Notice of Decision

Site Plan Review and Tentative Replat

SP-32-21 and RL-08-21

525 4th Ave SW

1
 AO.1
SITE PLAN
 SCALE 1/8" = 1'-0"

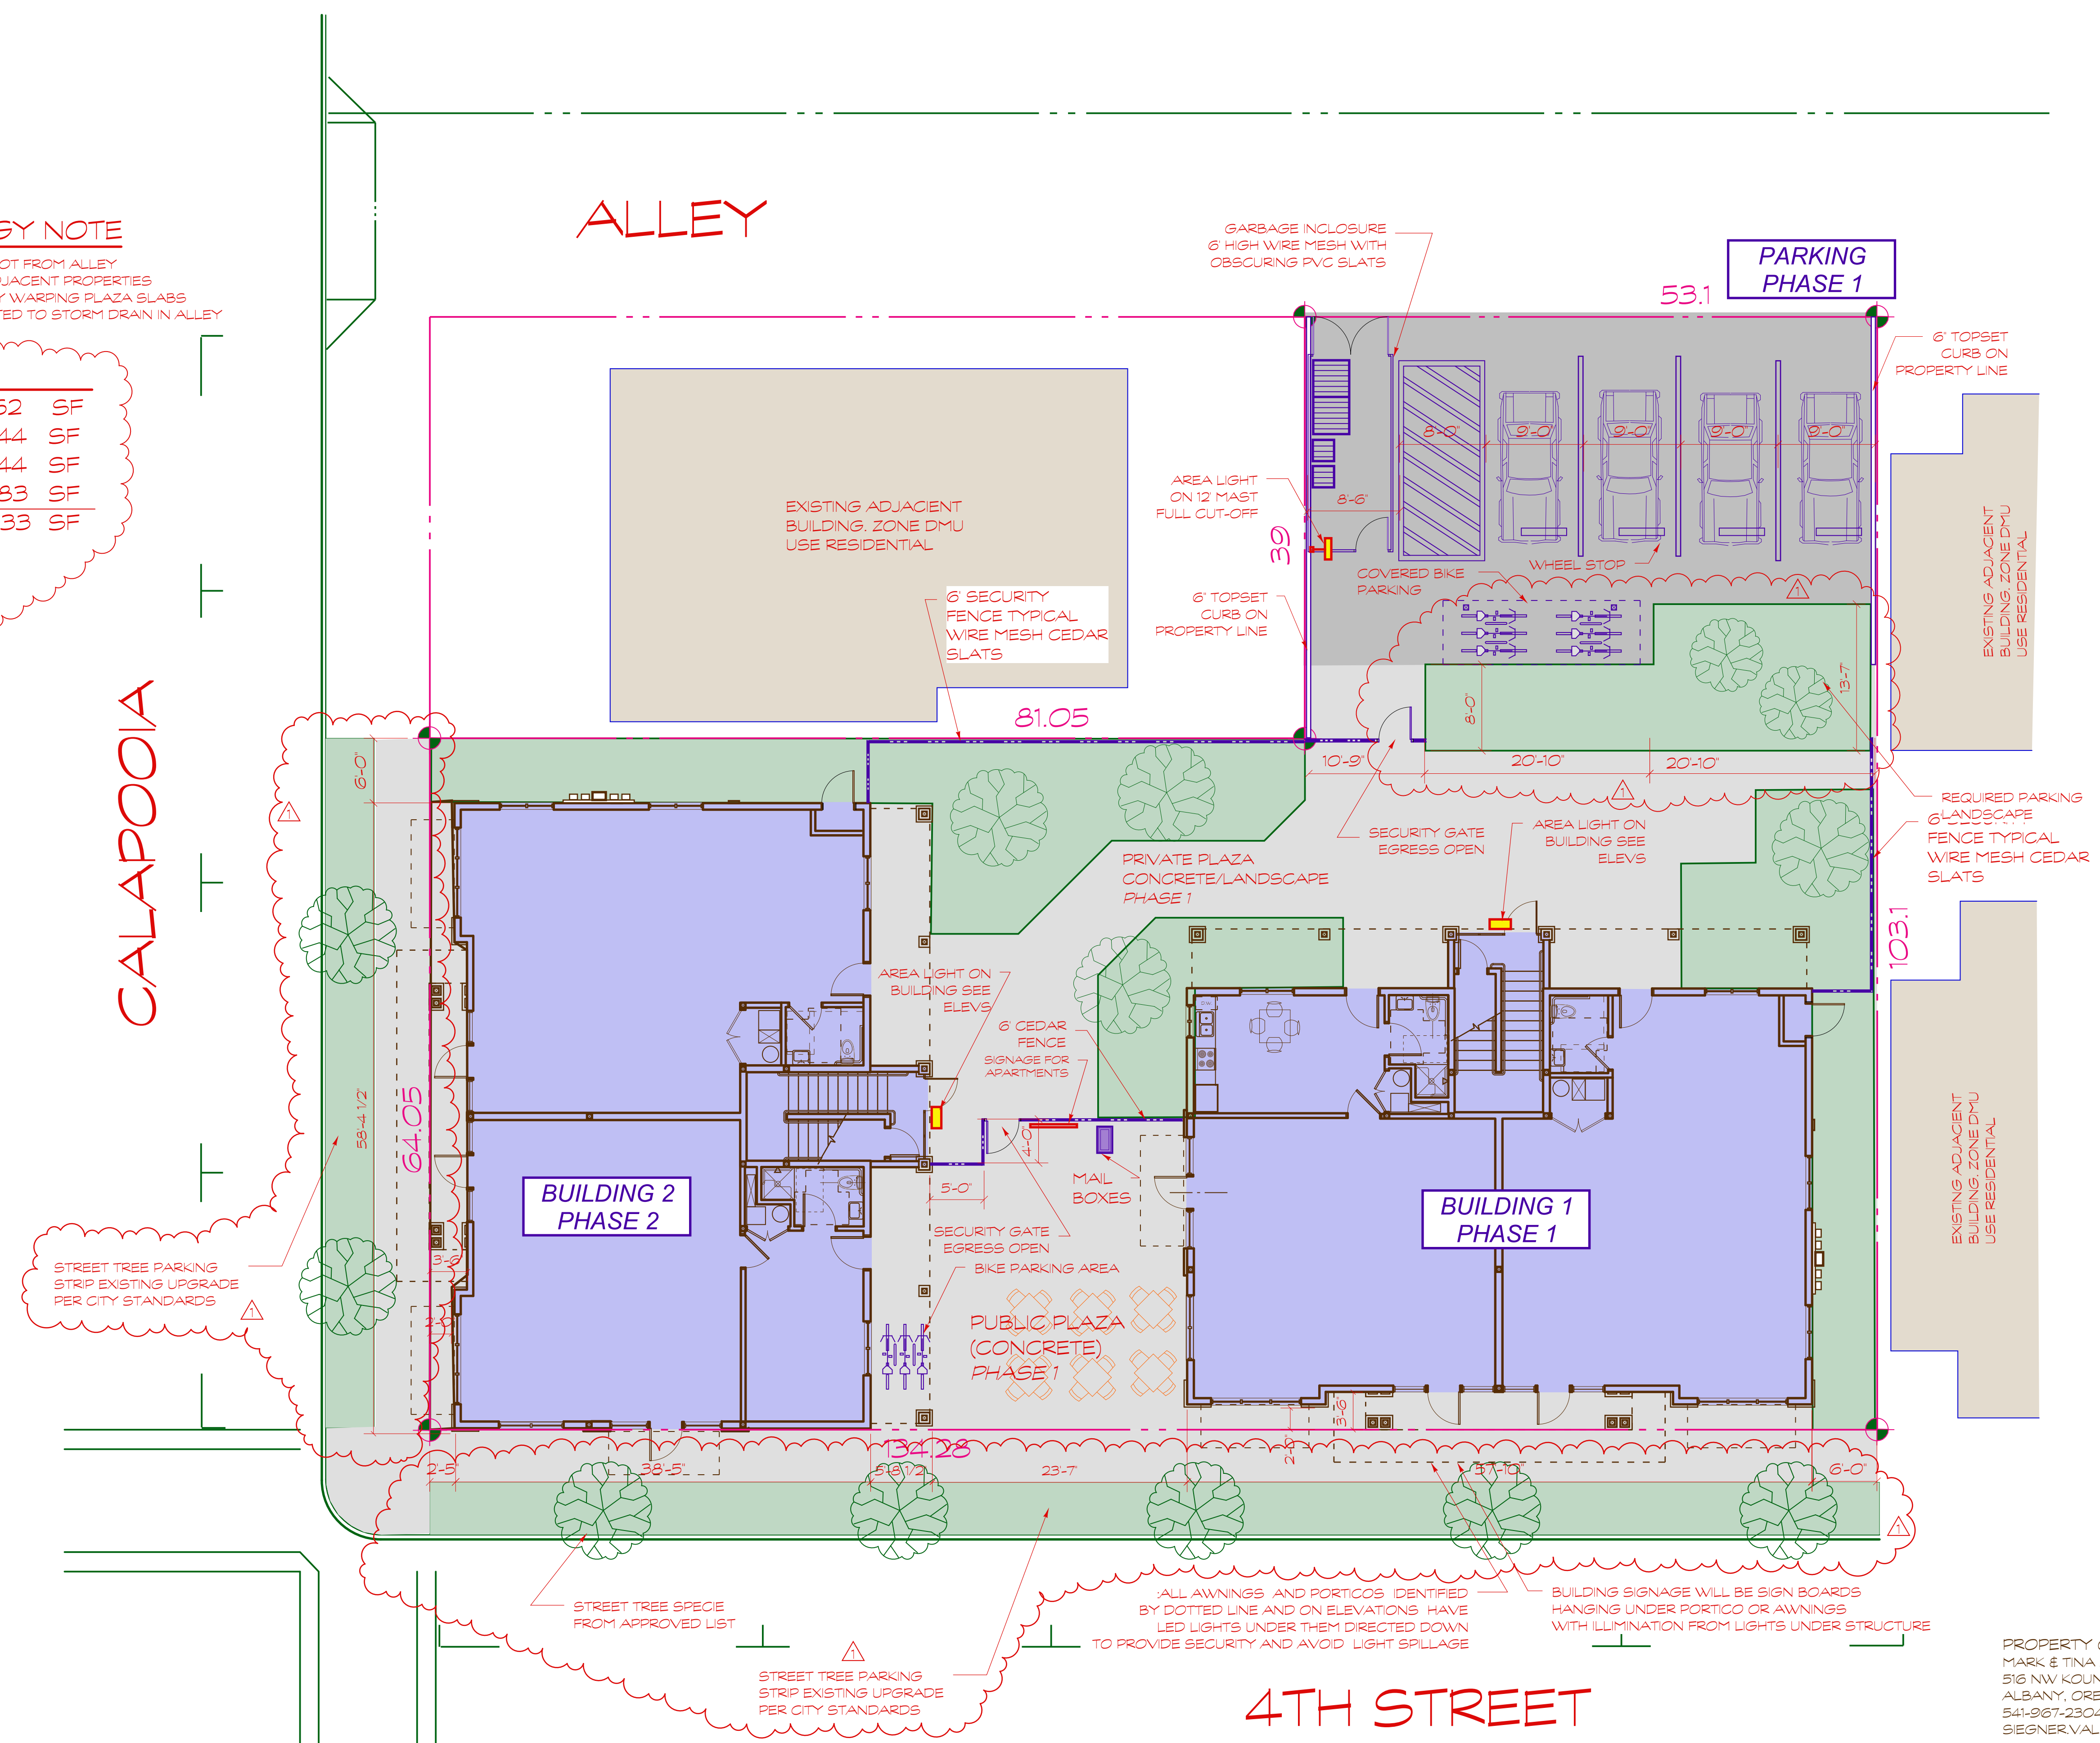
- Condition 8** Prior to issuance of an occupancy permit, the applicant shall replace the existing sidewalk along the site's street frontages as shown on the approved site plan.
